RFI1 to DPIE

Project No. 18095

TALLAWONG STATION - PRECINCT SOUTH

DA SCHEME

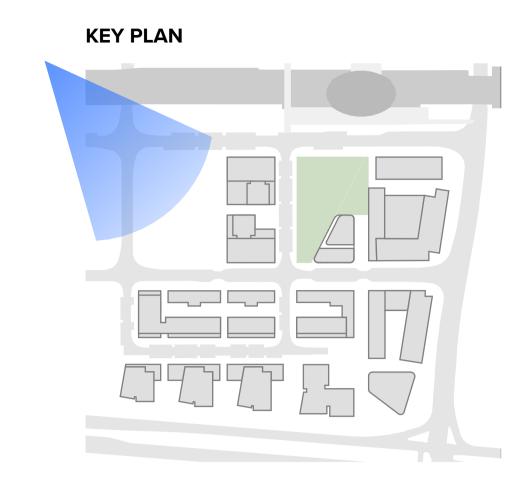
i. Illustrate how the proposal complies with Condition B3 (a) and (b) of SSD 9063 which requires consideration of:

a. design the built form and landscape of the blocks fronting Schofields Road, including setbacks to the topmost floor, to address the urban qualities of Schofields Road and the adjacent low-density residential suburb of The Ponds

- ✓ The variation in height, bulk and scale found within the concept scheme has been maintained
- ✓ Building forms have been refined to improve amenity and performance for both the public domain and residences
- ✓ On Site 2C, the footprints and heights of buildings have been reconfigured to reduce the wall effect to Cudgegong Road, provide a view corridor from the plaza, and to provide a lower scale building to the pedestrian boulevard
